**SERP Worksheet for SDP-Related Finding at
Cooper Nuclear Station
Service Water Gland Seal Water Configuration Deficiency**

SERP Date: 7/15/04
Cornerstones Affected: Initiating Events and Mitigating Systems
Proposed Preliminary Results: Greater than Green - Violation of 10 CFR 50, Appendix B, Criterion V, failure to prescribe appropriate instructions for the restoration service water following maintenance

Licensee: Nebraska Public Power District
Facility/Location: Cooper Nuclear Station / Brownville, NE
Docket No: 50-298
License No: DPR 46
Inspection Report No: 50-298/2004-014 Special
Date of Exit Meeting: July 22, 2004
Inspectors: Scott Schwind; Steve Cochrum
Branch Chief: Kriss Kennedy

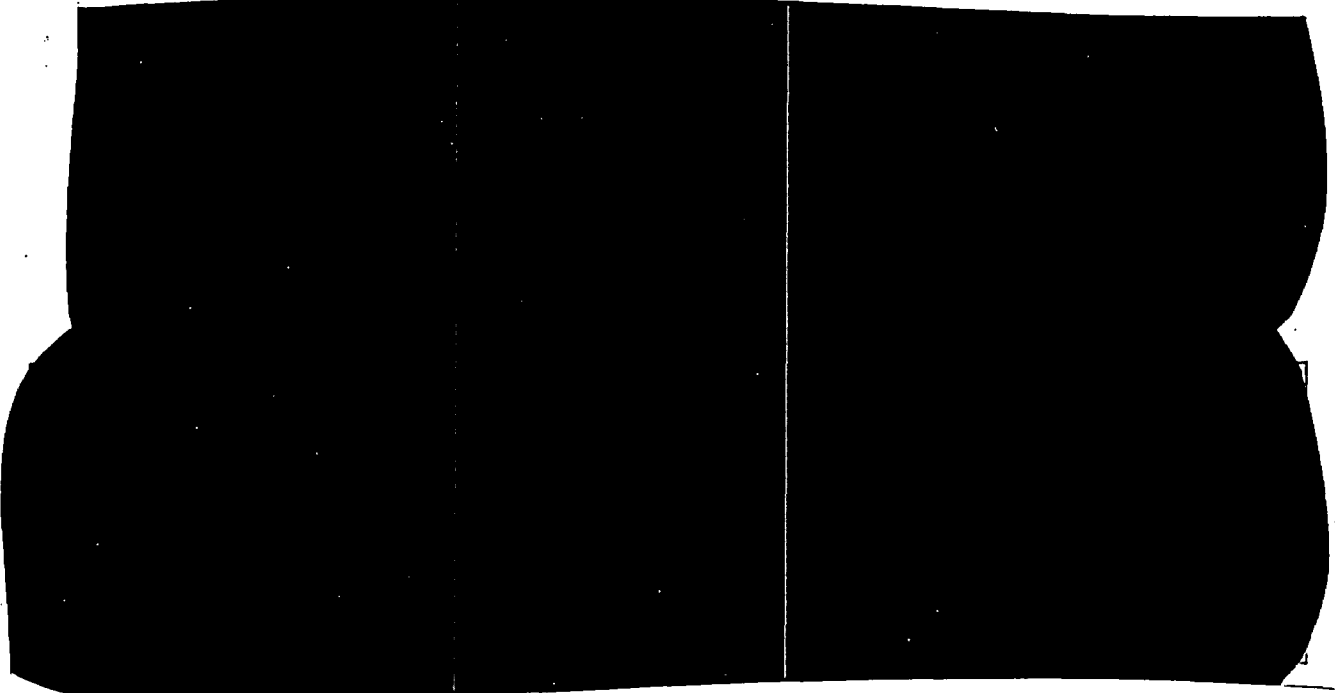
The licensee performed an assessment of the risk from this finding as documented in Engineering Study PSA-ES062, "Risk Significance of SCR 2004-0077, Service Water Gland Water Valve Mis-positioning Event." The licensee's result for internal risk was a Δ CDF of 3.85×10^{-7} . The analyst reviewed the licensee's assumptions and determined that the following differences dominated the difference between the licensee's and the analyst's assessments:

1. The licensee used a Human Error Probability of 9.2×10^{-2} for the probability that operators would fail to realign gland water prior to failure of the Division II pumps.

The analyst determined that this assumption was responsible for about 30% of the difference in the final results.

2. The licensee's model uses a Loss of Offsite power frequency of $1.74 \times 10^{-8}/\text{hr}$ as opposed the the NUREG/CR-5496 value of $5.32 \times 10^{-6}/\text{hr}$.

The analyst determined that this assumption was responsible for the vast majority of the difference in the final results. The analyst noted that the majority of risk was from core damage sequences that were initiated by a loss of offsite power.
